**ADVISORY BOARD ON  
RADIATION AND WORKER HEALTH**

**REVIEW OF THE SITE PROFILE FOR THE  
STANFORD LINEAR ACCELERATOR CENTER**

December 2011

Effective Date: December 20, 2011	Revision No. 0 – (Draft)	Document No. SCA-TR-SP2011-0011	Page No. 2 of 86
--------------------------------------	-----------------------------	------------------------------------	---------------------

**Figure 1. Neutron Spectrum from 46.6 GeV Electrons through Iron and Concrete**

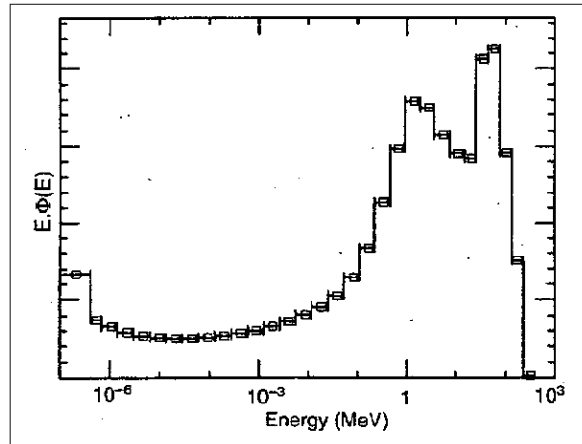
- 46.6 gigaelectron-volt (GeV) electrons
- 16° downstream of beam dump
- Through 4 ft of iron plus 5 ft of concrete
- Used Bonner spheres and plastic scintillators (20-MeV threshold) detectors
- Neutron dose rate was ~20 millirem (mrem)/hour (hr)
- Resulting neutron energy spectrum shown in the TBD (Figure 2-5), presented below in Figure 1:

The measurements used to derive several CFs for adjusting claimants’ neutron doses were obtained in 1997 under specific operating conditions. The TBD fails to demonstrate that these measurements are representative of the moderated neutron fields at various locations and time periods at SLAC. Shielding conditions, location, beam angles, reflected radiation (such as backscatter and skyshine), and other factors could significantly change the neutron energy spectra from those present under the specific measurement conditions of the 1997 data. This could significantly alter the fraction of undetected neutron dose from low-energy and high-energy neutrons, especially as beam energies changed over time. Several site experts interviewed by SC&A reported that accelerator beam power has decreased consistently from a peak period in the early 1970s, due to improvements in beam maintenance and modifications. It is not clear how a few neutron spectra obtained in the late 1990s can adequately characterize or bound dose corrections for workers at all affected locations and times throughout the site’s history.

**Figure 2. Neutron Spectra at SSRL through 2 ft of Concrete**

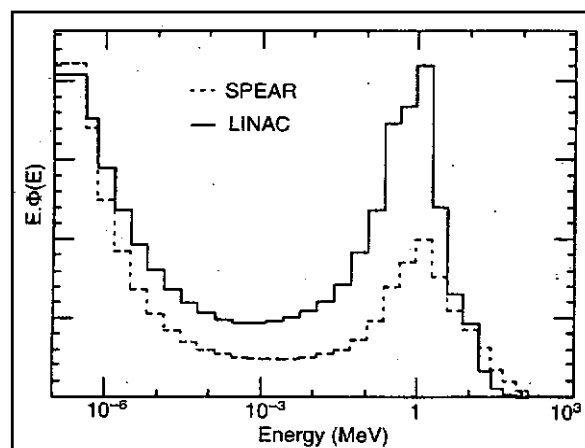
- 120-MeV electrons (LINAC); 2.3-GeV electrons (SPEAR)
- 90° to beamline
- Through 2 ft of concrete
- Used Bonner spheres and plastic scintillators (20-MeV threshold) detectors
- Neutron dose rate was not provided
- Resulting neutron energy spectra shown in the TBD (Figure 2-6) , presented below in Figure 2:
